This document contains the latest information about the AVR data book and the AVR data sheets.

8-Bit AVR[®] Microcontroller

AVR[®] Data Book Updates and Changes

Figure 34 Serial Programming and Verify

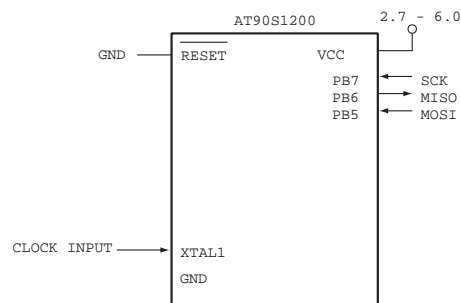
2-44 Replace figure 34 by the one below:

Figure 53 Serial Programming and Verify

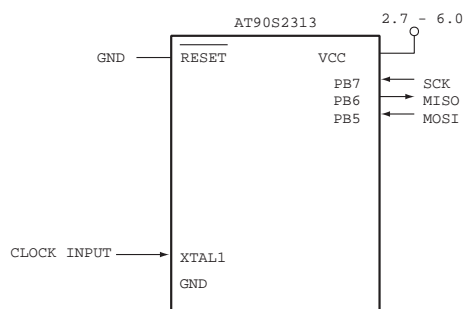
- 3-54 in the **Port D Input Pins Address - PIND** description, change the Initial Values of bits 0 to 6 from “Hi-Z” to “N/A”.
- 3-67 Replace figure 34 by the one below:

Figure 66. Serial Programming and Verify

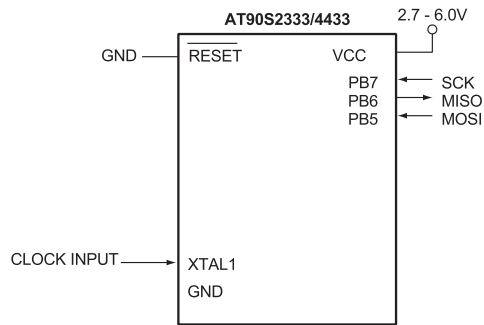
- 5-68 In the **Port D Input Pins Address - PIND** description, change the Initial Values from "Hi-Z" to "N/A".
- 5-80 In **"Serial Downloading"**, replace Figure 66 by the figure below.

Figure 64 Serial Programming and Verify

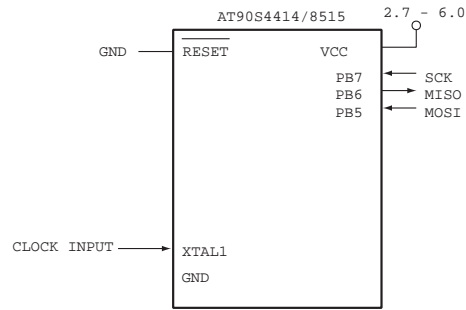
- 6-66 in the **Port D Input Pins Address - PIND** description, change the Initial Values from “Hi-Z” to “N/A”.
- 6-79 Replace **figure 64** by the one below:

Figure 40. SPI Transfer Format with CPHA = 1 and DORD = 0

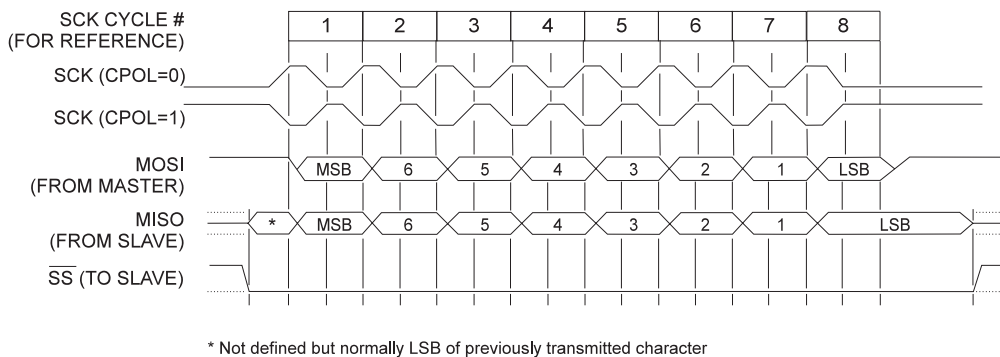
7-52 Change **Figure 40** to the figure below.

Figure 71. Serial Programming and Verify

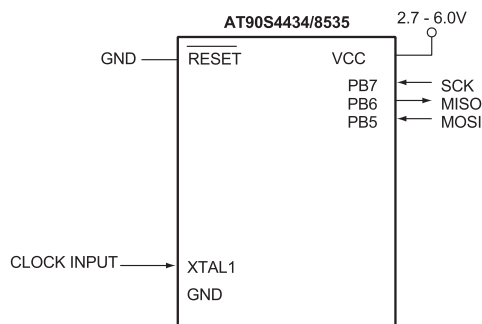
7-91 In “**Serial Downloading**”, replace Figure 71 by the figure below.

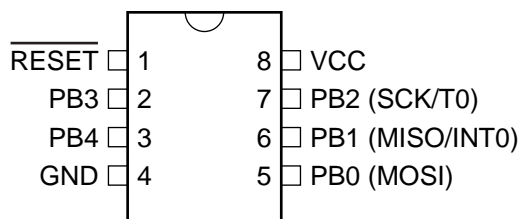
11-3 Replace **Pin Configuration** by the figure shown below.

Figure 39. SPI Transfer Format with CPHA = 0 and DORD = 0

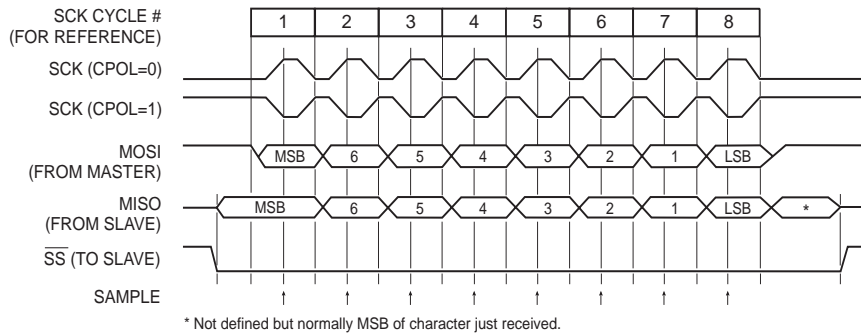
- 13-59 Replace figure 39 and 40 by
